Well Name: FEDERAL I

Well Number: 8

Sundry ID: 2668163

Type of Action: Plug and Abandonment

Proposed P&A

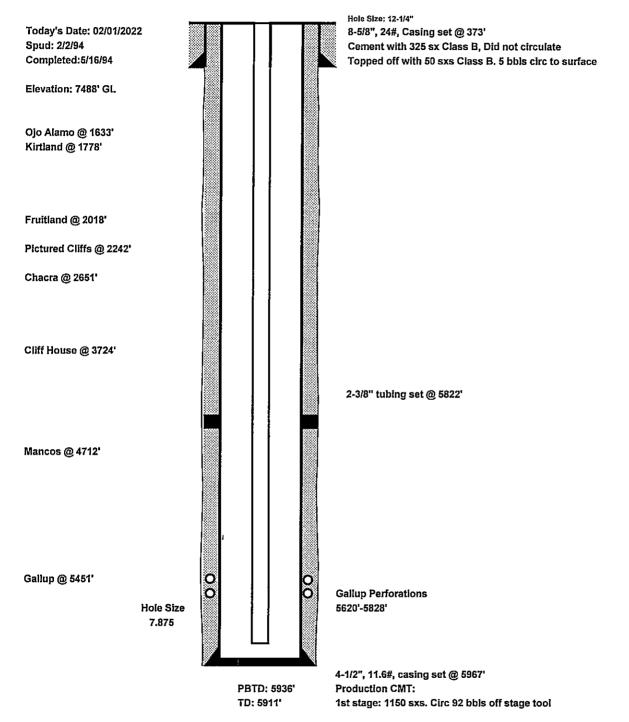
- 1. Plugging operations authorized are subject to the attached "General Requirements for Permanent Abandonment of Wells on Federal and Indian Lease."
- 2. The following modifications to your plugging program are to be made:
 - a. Add a plug to cover the Chacra formation top at 2651'.
- 3. Farmington Office is to be notified at least 24 hours before the plugging operations commence (505) 564-7750.

- No well log available for subject well. Operator submitted tops are acceptable based on Reference Well #1.
- Add a plug to cover the Chacra formation top at 2651'.
- The plugs proposed in the P&A procedure, with recommended changes, will adequately protect any freshwater sands in this well bore.
- Gallup perfs 5620' 5828'.

You are also required to place cement excesses per 4.2 and 4.4 of the attached General Requirements.
